**LOW IMPACT DEVELOPMENT & HYDROLOGY REPORT**  
FOR

514 Prospect Ave.,  
Redondo Beach, CA 90277

Prepared for:  
**City of Redondo Beach**

Prepared by:  
**Labib Funk + Associates**  
**Structural | Shoring | Civil Consulting Engineers**  
319 Main St.  
El Segundo, California 90245  
JLA Job # 22709  
January 25, 2022

Hydrograph: Beach City Health District - Site

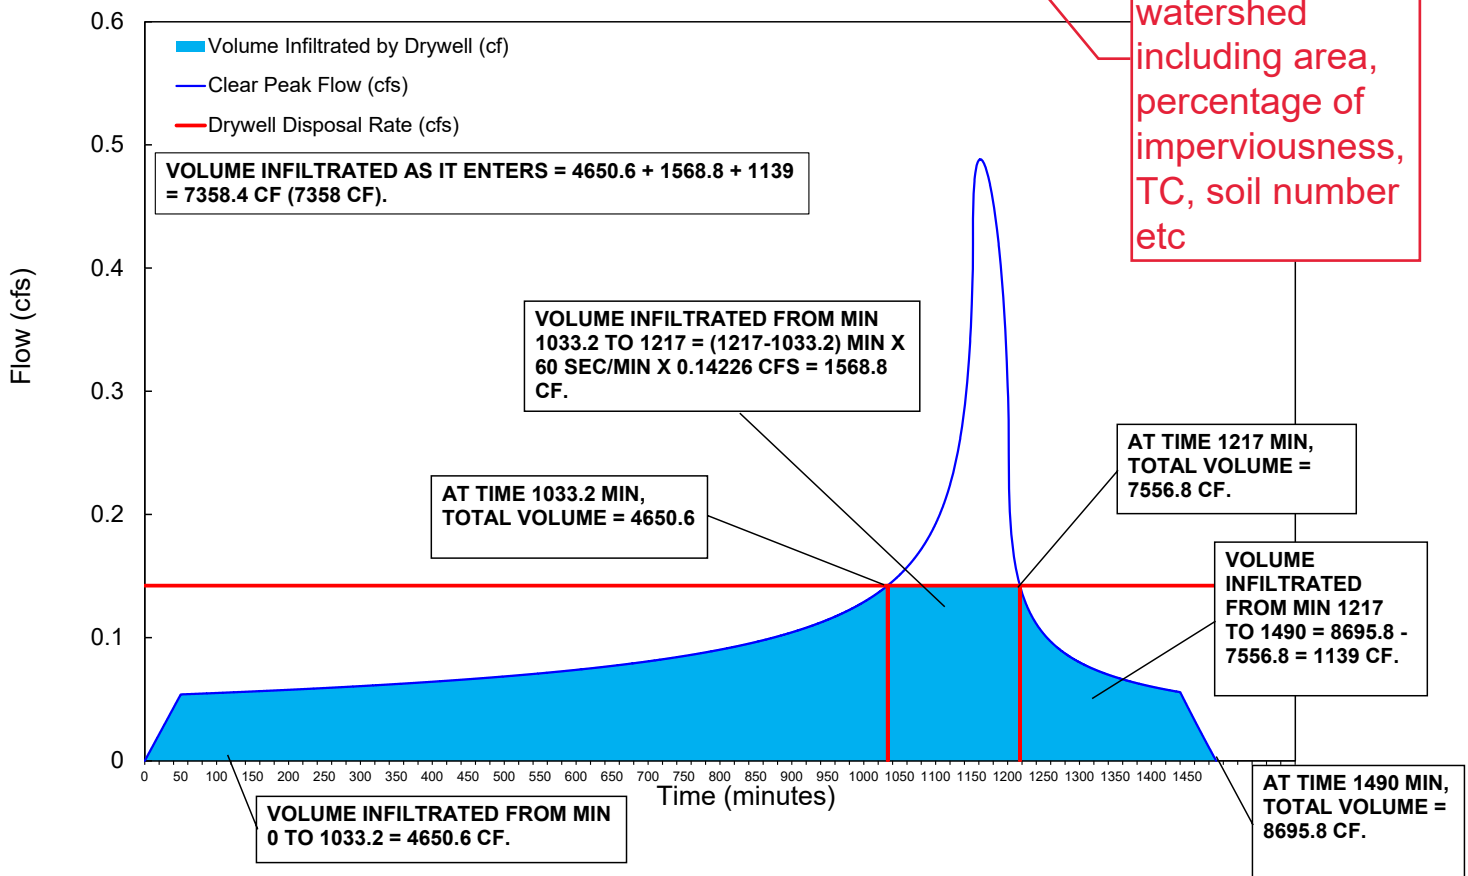
Provide Hydro Calc work sheet for each sub-watershed including area, percentage of imperviousness, TC, soil number etc

Provide details  
about each  
parameter with  
backup  
information

C-300

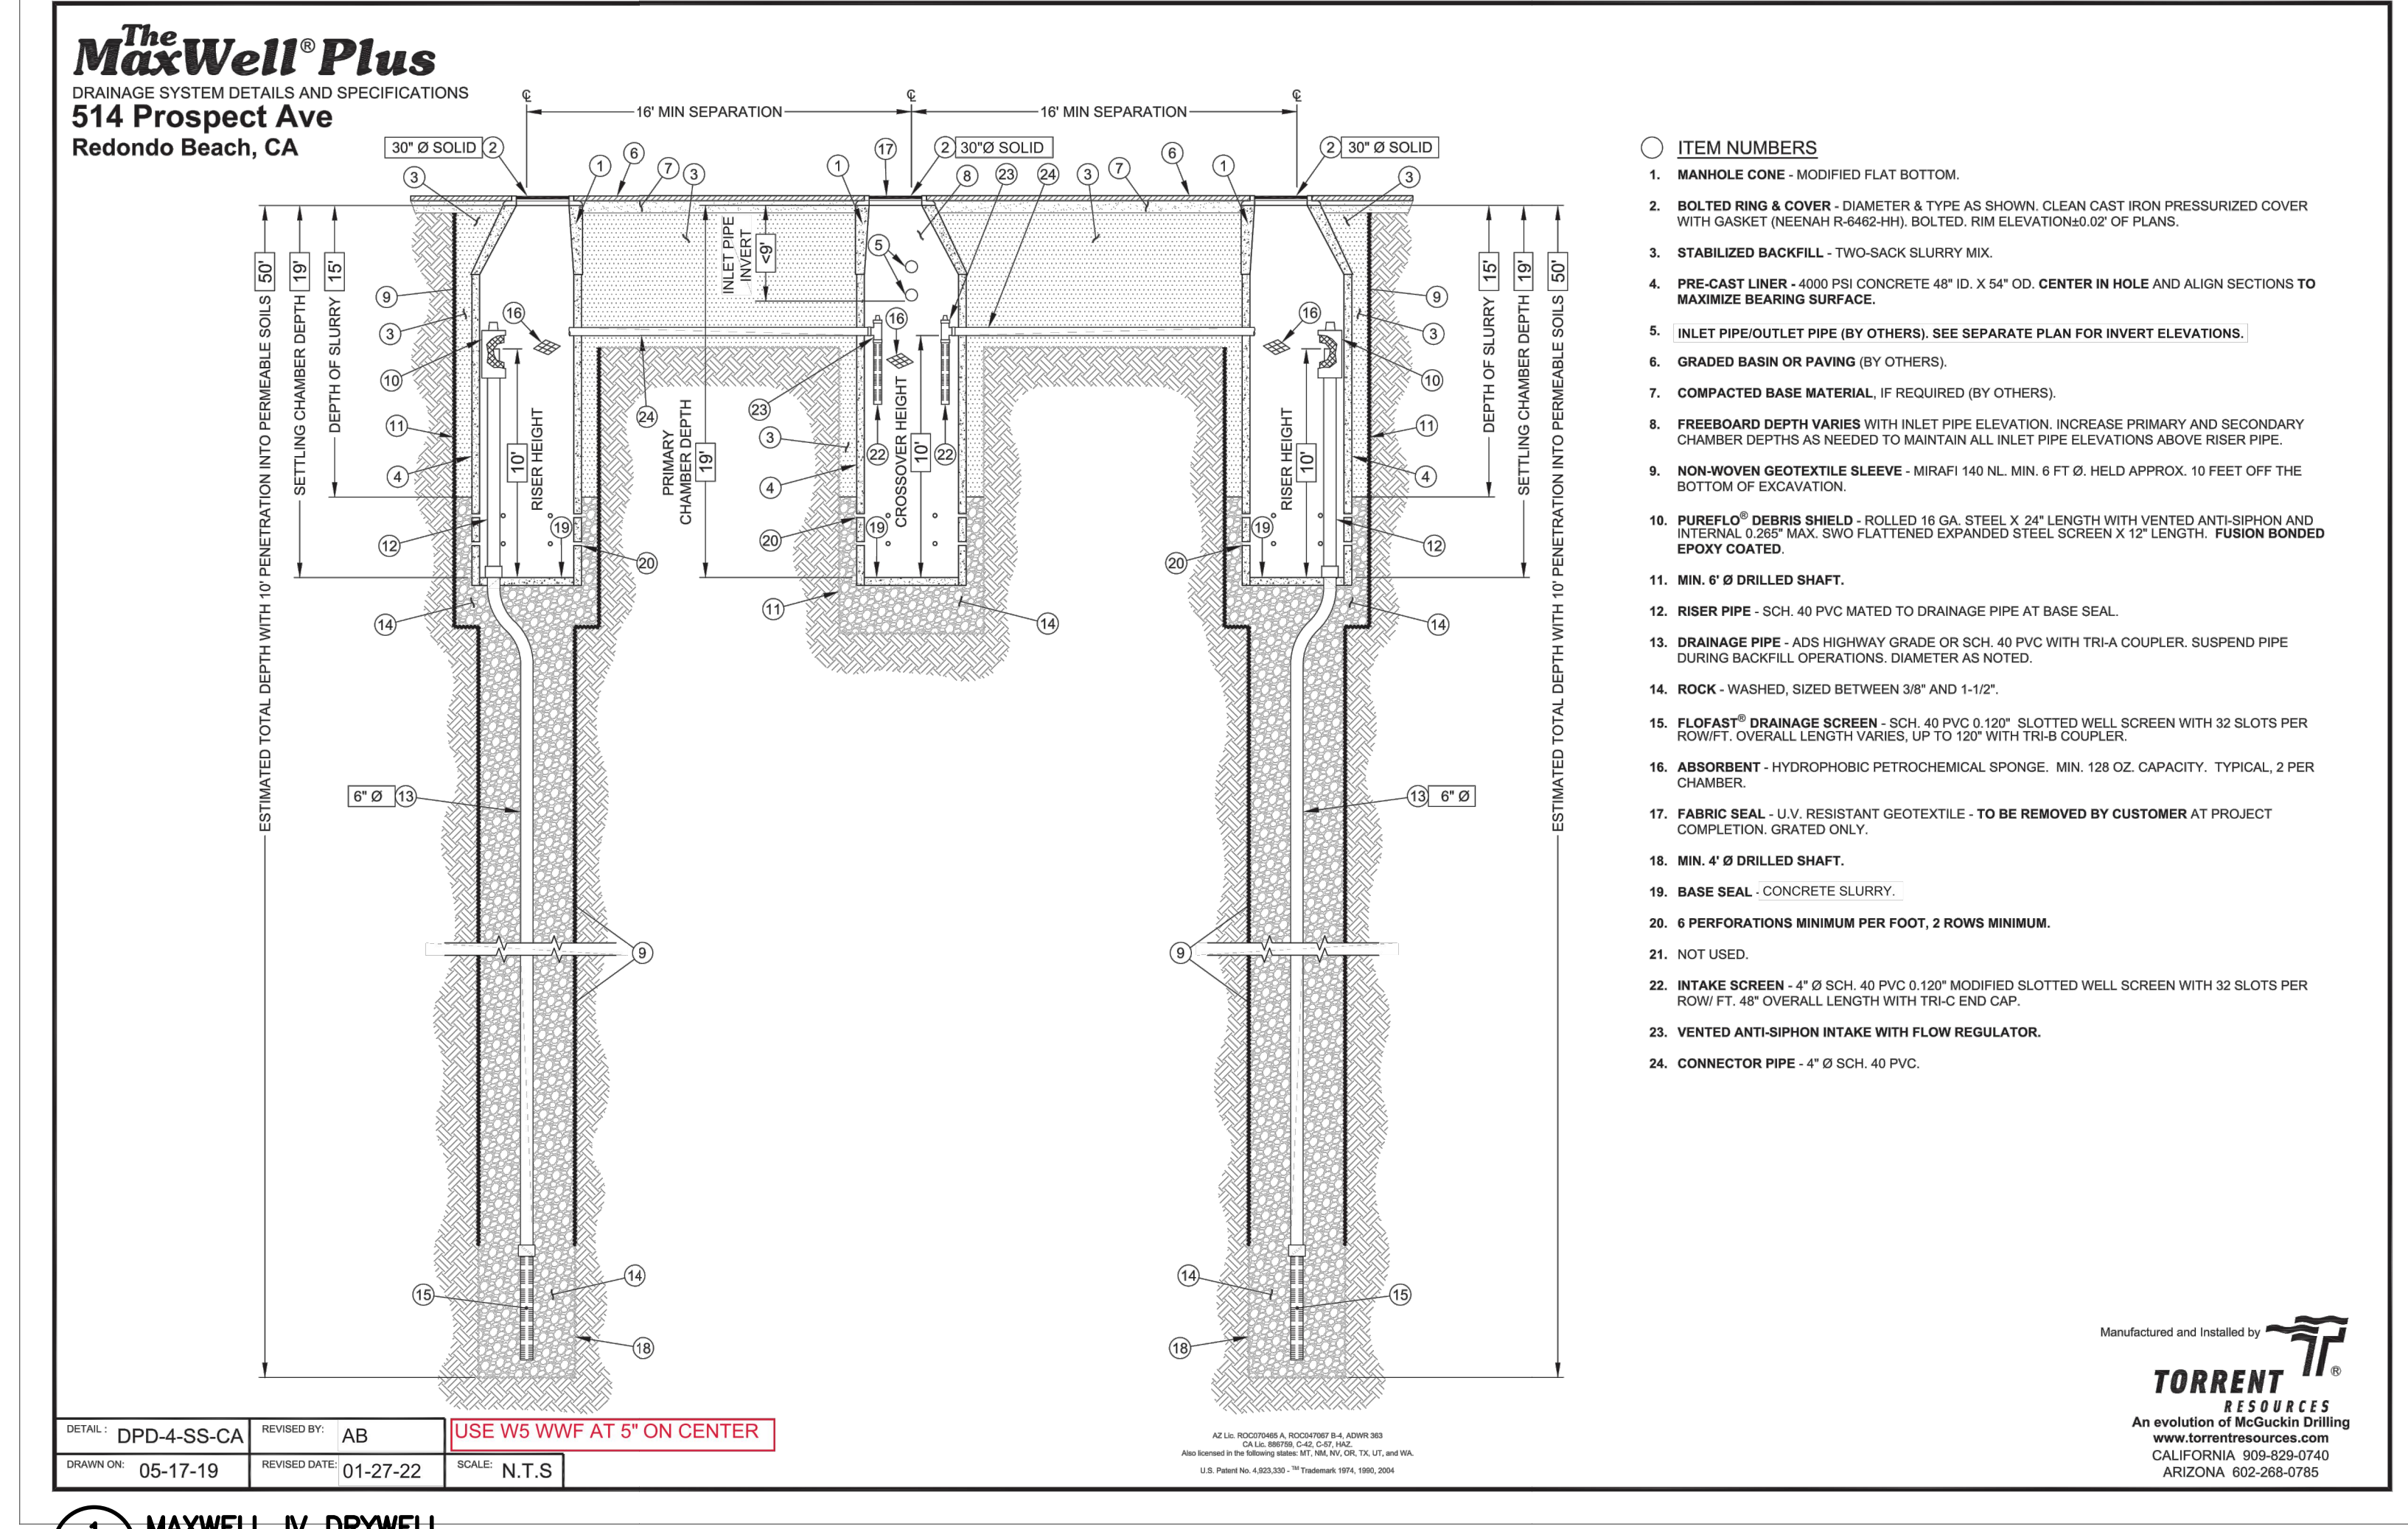
- 1) provide hydrology map for both existing and proposed condition
- 2) provide detailed hydrology and LID calculation using hydro calc, provide input data .
- 3) provide sump pump calculations
- 4) The stormwater emanating from the project site tributary to the City of Redondo Beach shall drain directly into the storm drain at a rate of no more than one (1) cubic foot per second, per acre of a site. Provide hydrology/ hydraulic calculations for design storm -25 years.
- 5) Obtain City of Torrance approval for stormwater discharge requirement for their tributary area.

Flow shall be routed to BMP
